# **AEROPRAKT**

## **SERVICE BULLITEN**

### **No. SB A-32-07**

**Model: A-32**

Photo 12

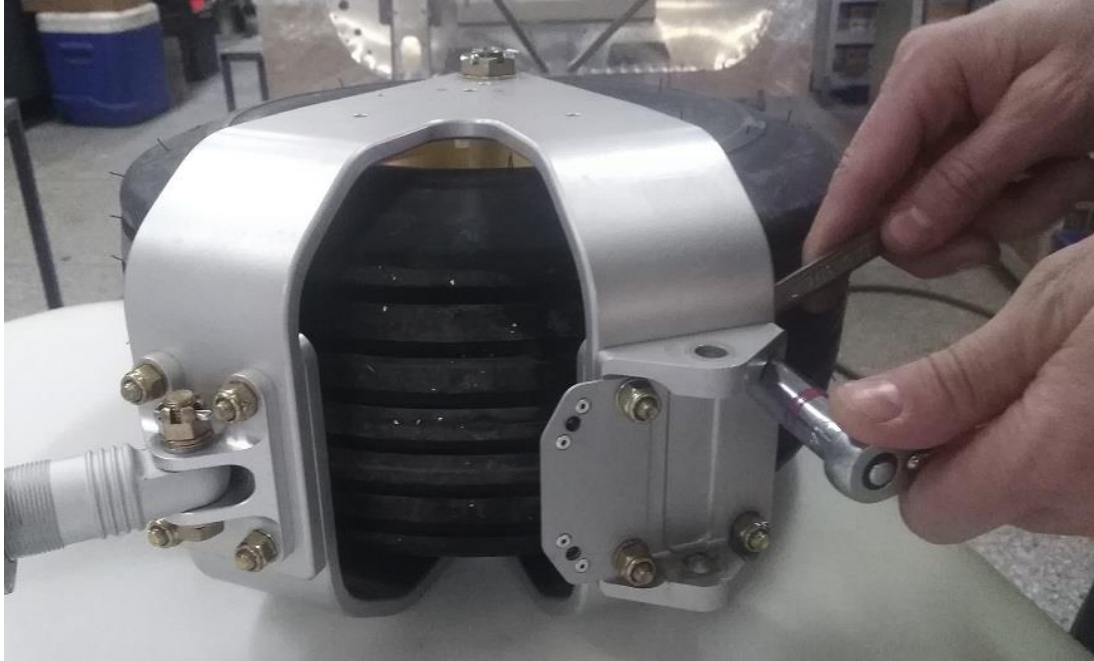
3.11) Undo the nuts attaching the bracket to the wheel fork (Photo 12).

**Photo 14**

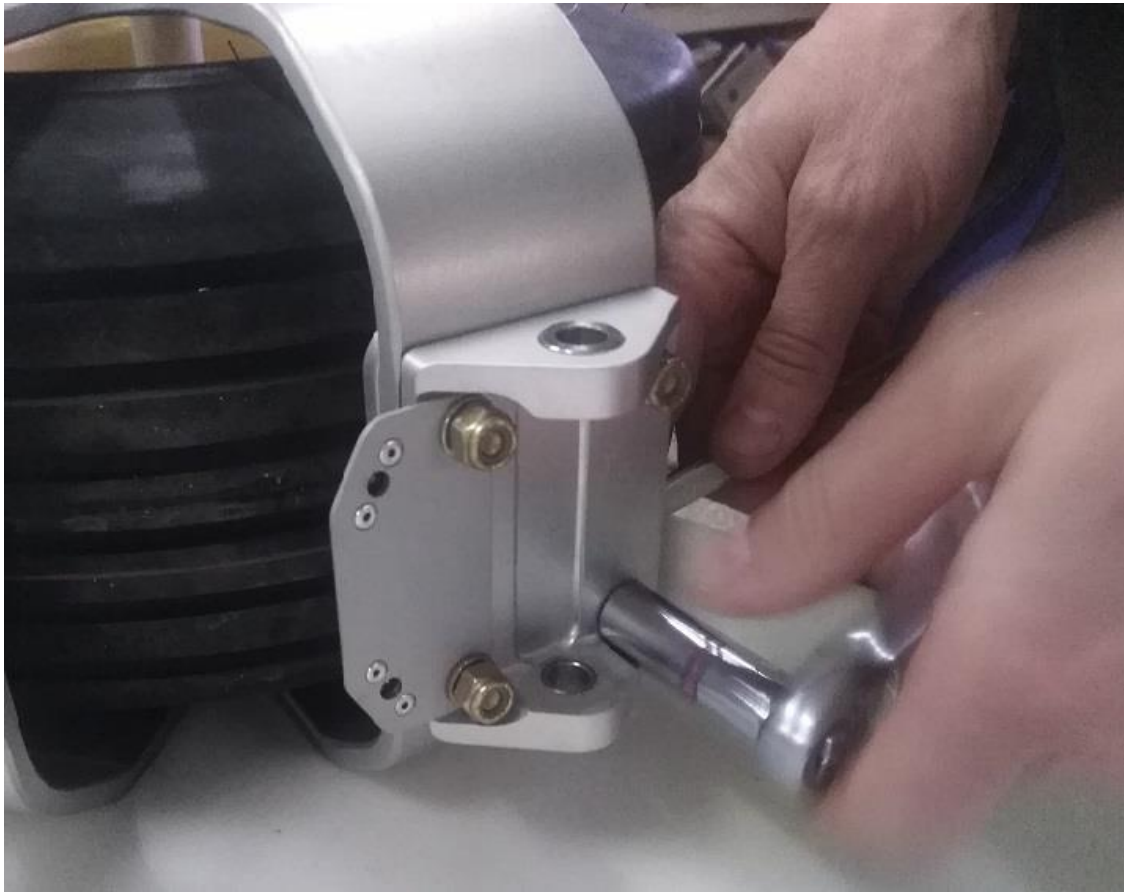
**3.13)** Install the new bracket and tighten the nuts (Photo 14).
